DOCUMENT CHANGE REQUEST

DCR number 266 Changes required for: General

Title: Transistors Low Power RF NPN, based on type 2N3019

Number: 5201/011

VOLTAGE WAVEFORMS

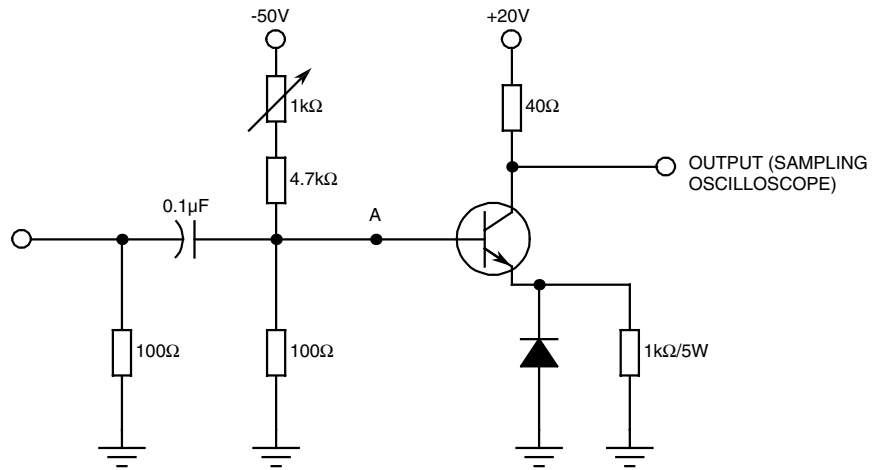
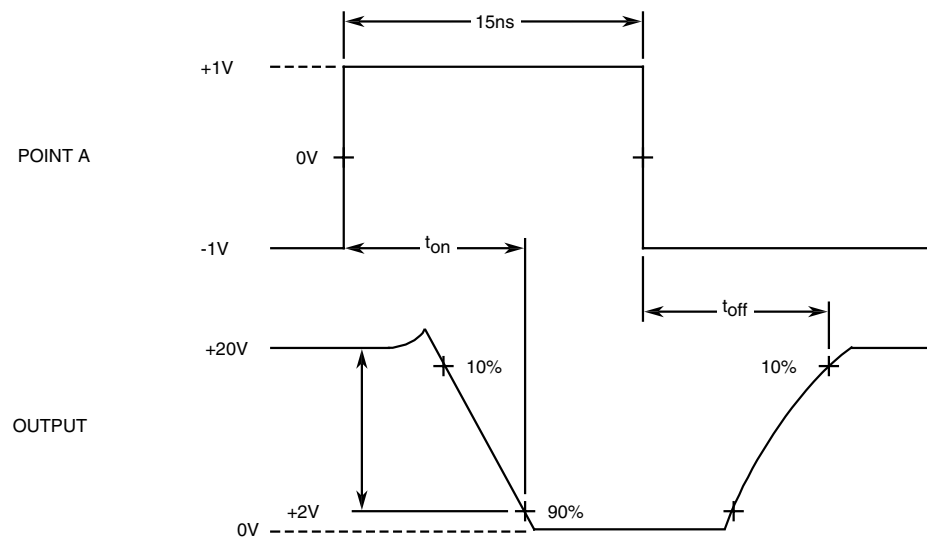
14. Table 2 . The test condition for tCB corrected from VCE to VCB to align with the MIL specification test definition.
 15. Table 2 and Figure 4 - For tON and tOFF tests a new Note 4 added which fully defines the tests based upon the test circuits and conditions used by STM and MIL specification, showing the test circuit and the corrected waveforms.
